Re: Mortdale SSD 7421 Response to queries from the Department of Planning and Environment

Skylife Properties Pty Ltd has prepared a response to emails from the Department of Planning and Environment dated 26 September and 30 October 2017 seeking clarification on matters relating to the Mortdale State Significant Development application.

**WOLLI CREEK & GEORGES RIVER
CATCHMENT AREAS**

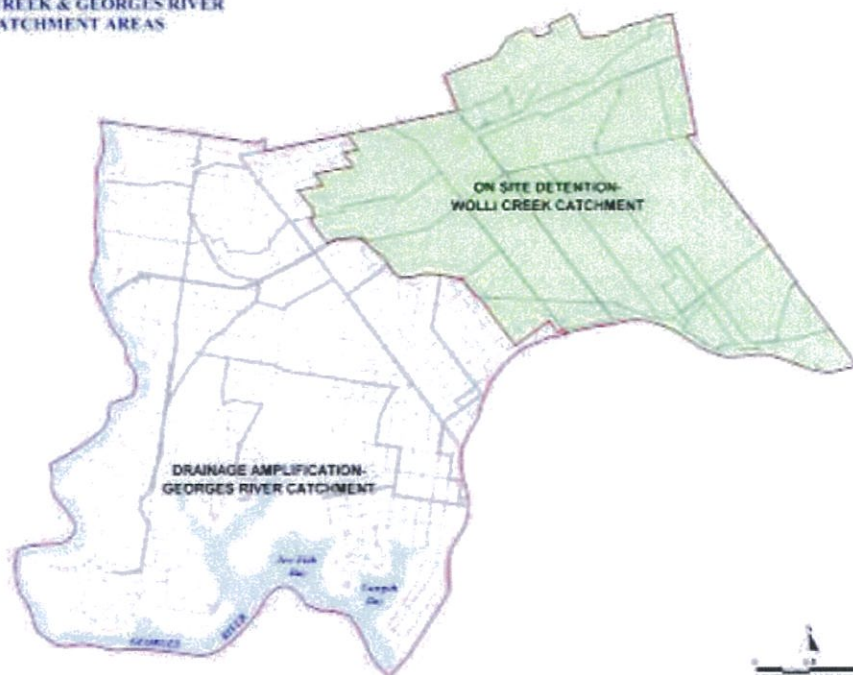
Whilst it is acknowledged that the predicted stormwater runoff volumes would not greatly change from the existing situation, adequate assessment of the proposed stormwater drainage system's capacity to cope with rainfall events has not been provided. It should be noted that the Georges River DCP (Section 3.7) requires onsite stormwater and drainage control to be designed for the 20 year ARI storm, with overland flow paths designed for the 100 year ARI event. Details of all modelling (e.g. DRAINS) of the stormwater system should be provided.

Councils Drainage and On Site Detention Policy found in Appendix 2 of the DCP indicates that the Hurstville area is broken up into the Wolli Creek Catchment nominated as the "On Site Detention" area and the Georges River Catchment which is noted as the "drainage amplification" area. The map follows.

As the subject site is located in the Georges River Catchment area, it appears that on site detention may not be required at this site.

To ensure that this is the intent of the DCP, a discussion with a council engineer (23 October 2017) revealed the following;

- That Appendix 2 is an old document that should have been updated when the DCP was revised.
- That if the proposal is submitted to council, that despite what Appendix 2 indicates that they will require OSD.
